Silverleaf Solar Farm Pty Ltd

120 MW Solar Farm Response to Submissions

November 2020

FIGURE 3-1

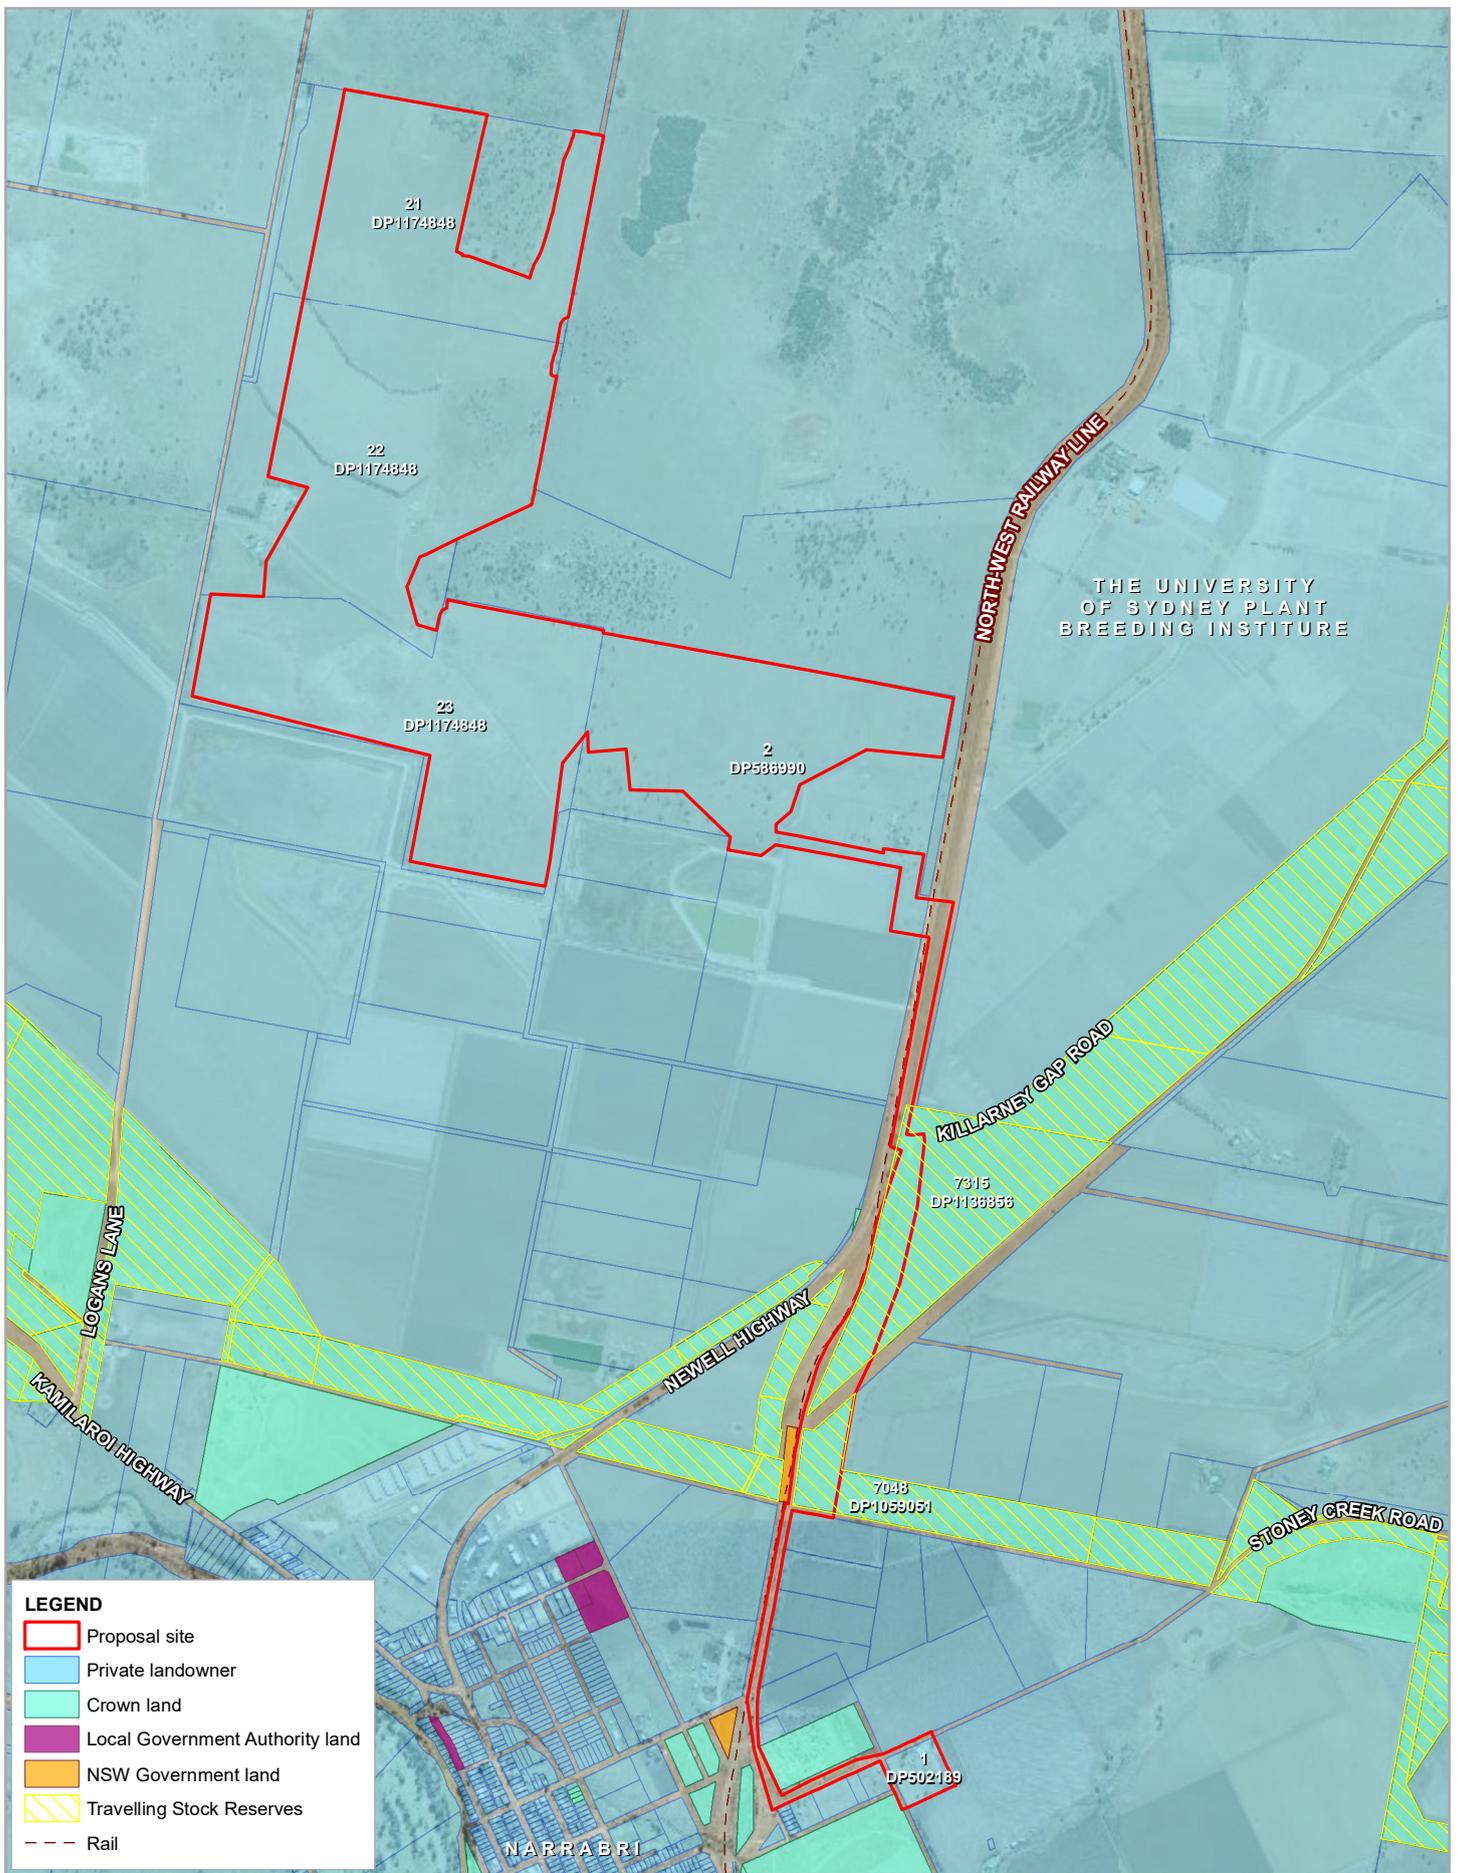
1. Request for a figure clearly showing the Development Application area for the proposal, a schedule of lands listing all relevant land parcels (inclusive of land parcels associated with the transmission line corridor) as well as the provision of any correspondence to date with Crown Lands in regard to landowners consent is requested (for the purposes of satisfying Clause 49(1) and Clause 50(1)(a) of the EP&A Regulation).
2. Confirmation if receiver R15 is an “associated” landowner.

Item 1: ENGIE has prepared a figure to show the Development Application area for the proposal (Figure 3-1). All relevant land parcels (including all land parcels associated with the transmission line corridor) are shown in Table 3-2.

FIGURE 5-1

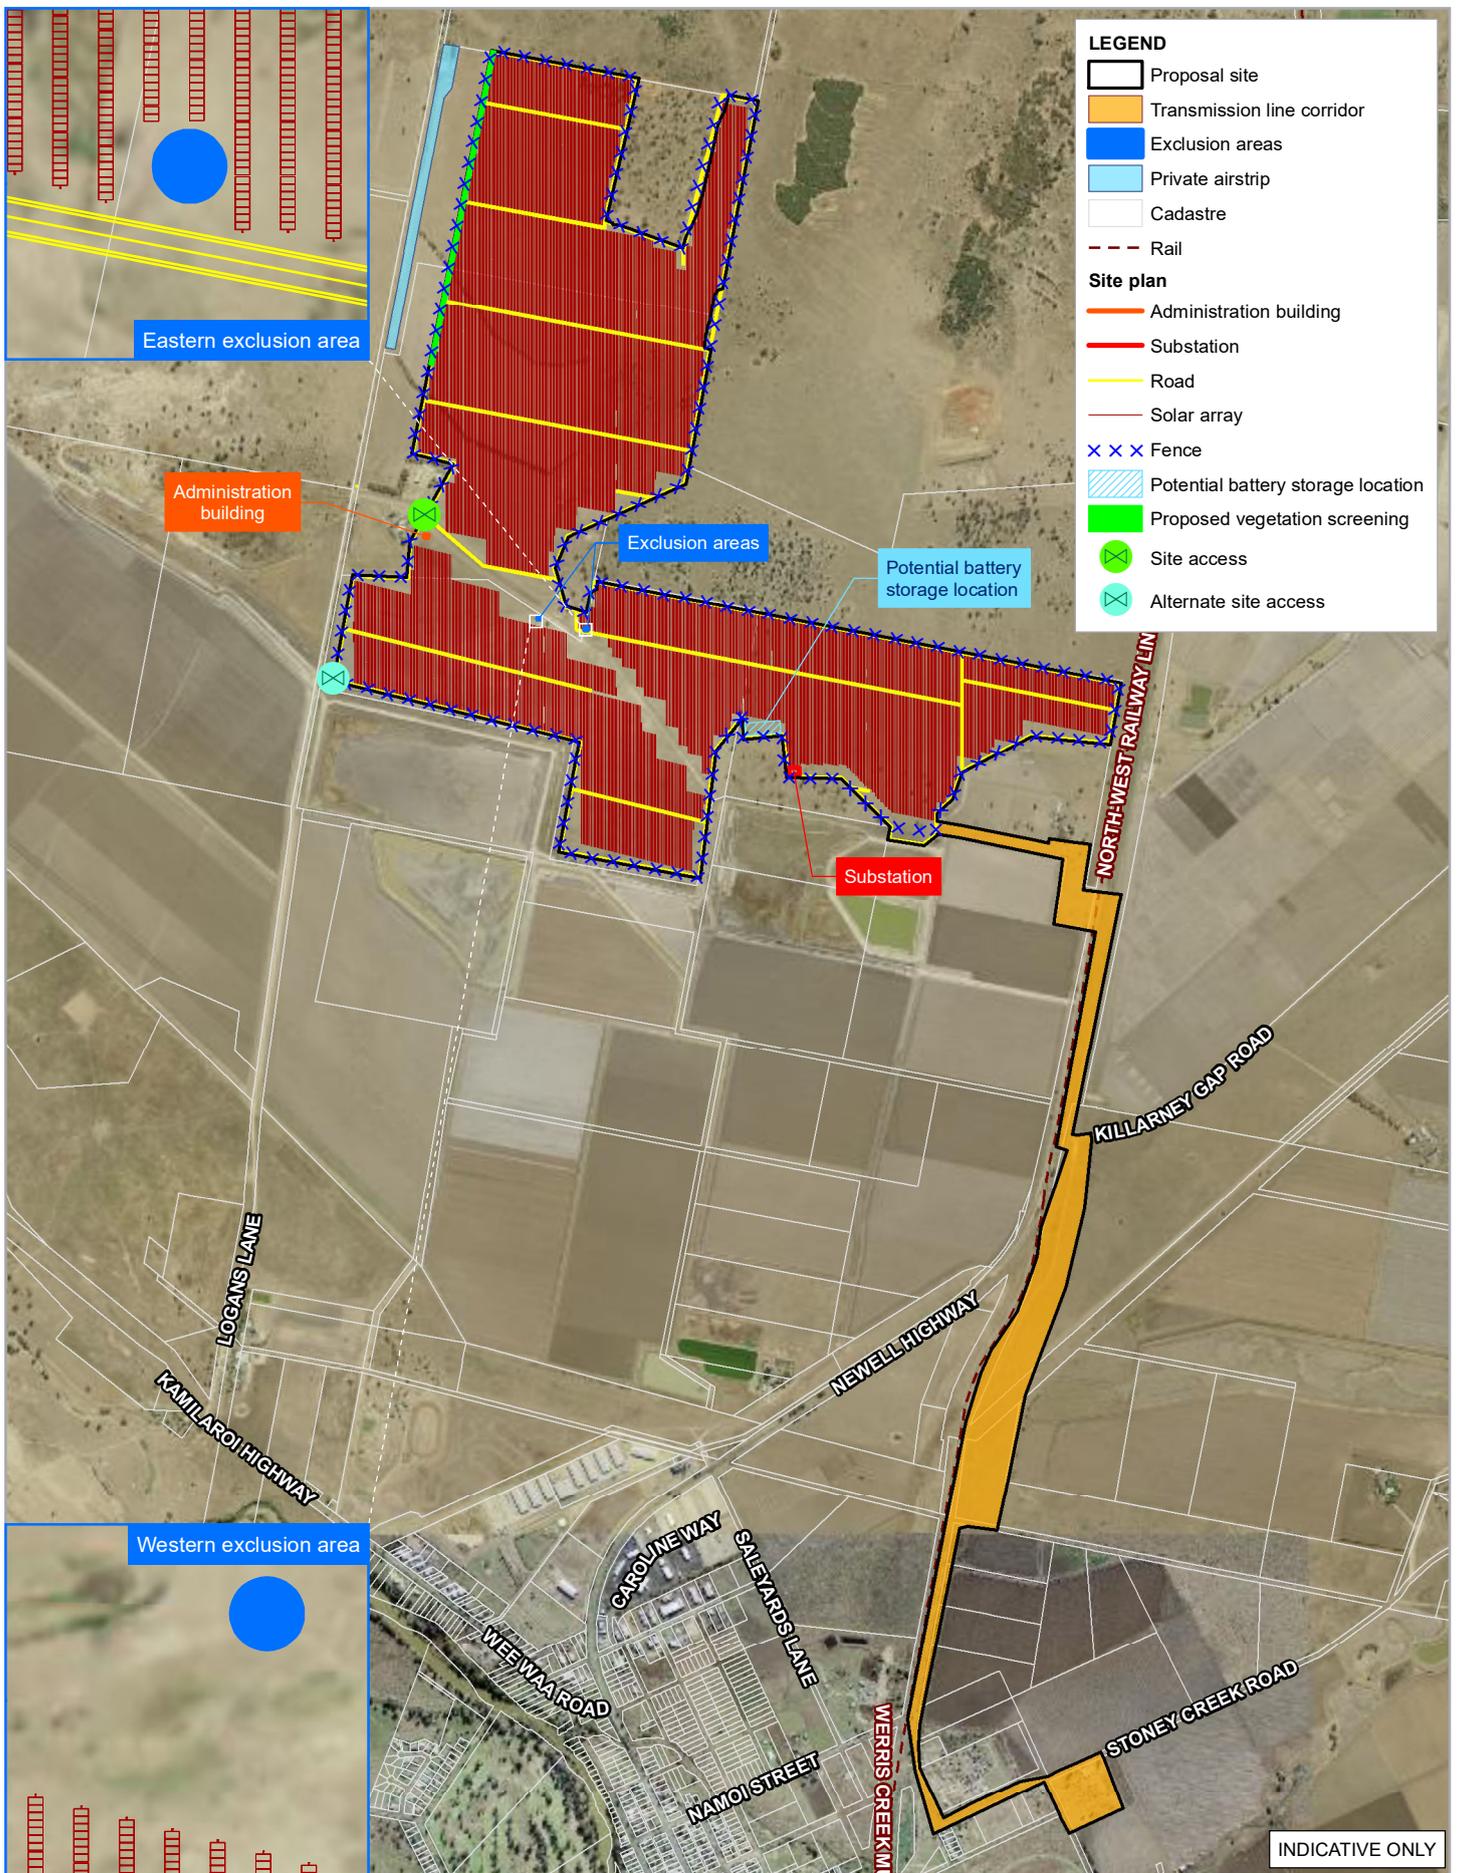
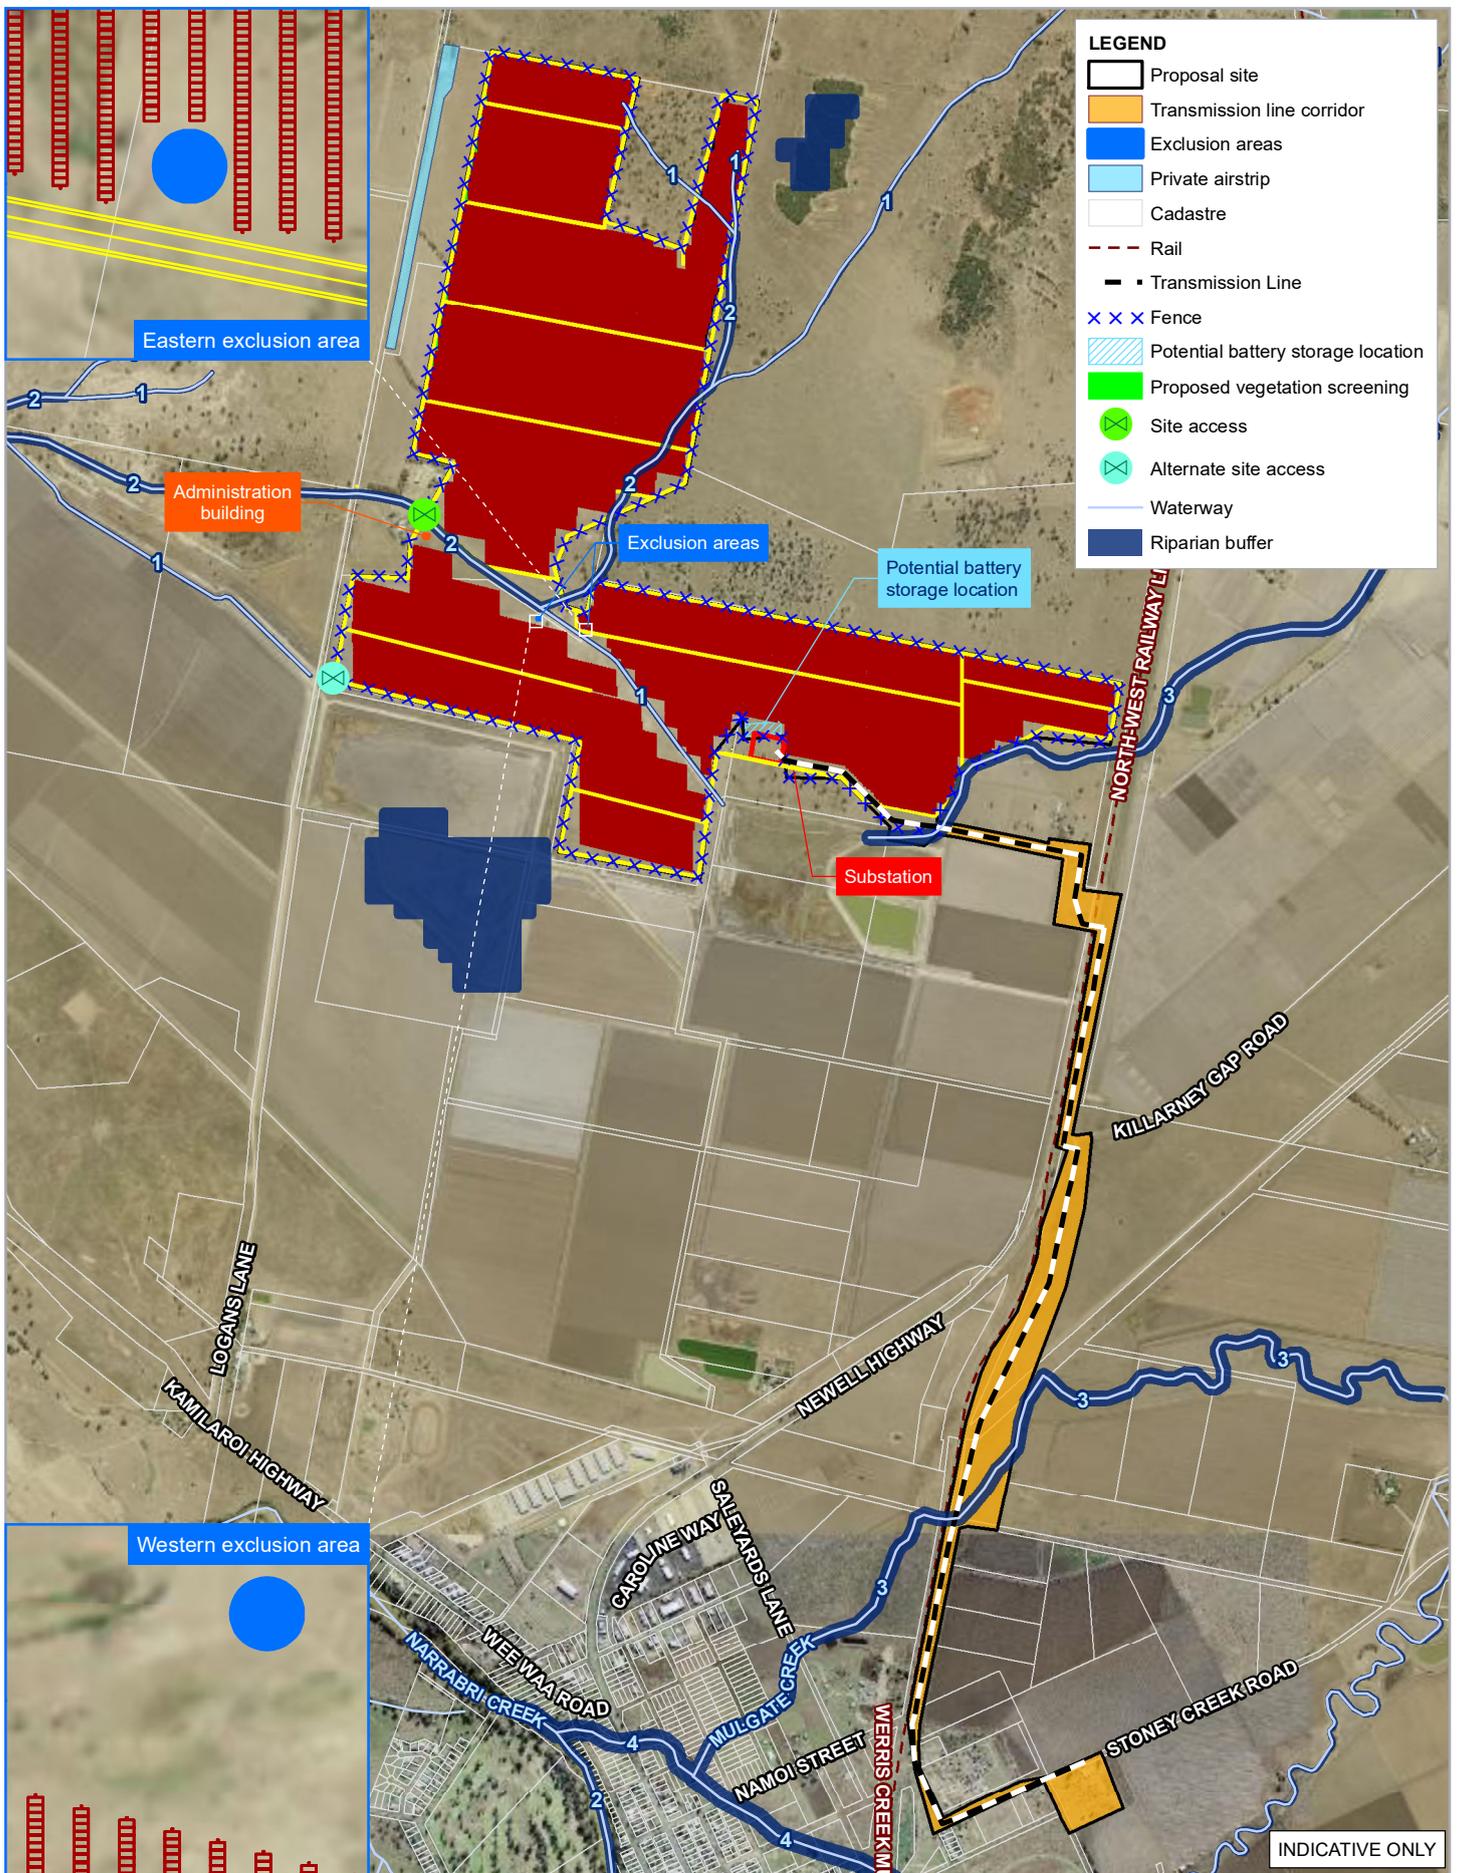
- 1 The native vegetation extent does not appear to have been mapped in accordance with the Biodiversity Assessment Method (BAM). Section 4.3.2 of the BAM requires that both woody and non-woody native vegetation be assessed on the site and within a 1500 metre buffer of the development site.
- 2 Comparing the aerial image with the mapped native vegetation extent (Figure 4-1), it appears that areas of woody vegetation likely to be native have not been fully mapped.
- 3 There is no derived native grassland included with mapped native vegetation extent, despite this being identified on the proposal site. Native vegetation on the proposal site, which includes derived native grasslands shown in Figure 5-1, has not been mapped as part of the native vegetation extent.

Since exhibition of the EIS, the proposal site has been reduced to exclude a vegetation zone (Zone 6. PCT 397 Poplar Box – White Cypress Pine shrub grass tall woodland of the Pilliga-Warialda region, Brigalow Belt South Bioregion) from the proposal site (see Figure 5-1 and Figure 5-2).

This vegetation zone was removed from the proposal site to minimise impacts to biodiversity. As outlined above in 4.8, PCT 397 within the proposal site is not considered to conform to the nationally listed EEC, Poplar Box Grassy Woodland on Alluvial Plains. Regardless, it has always been the intention to avoid any direct impacts to the woodland form of PCT 397. Indirect impacts on this PCT would be avoided through the safeguards and mitigation measures outlined in section 6.2.3 of the EIS. The BDAR for the proposal has been updated to reflect the avoidance of this community.
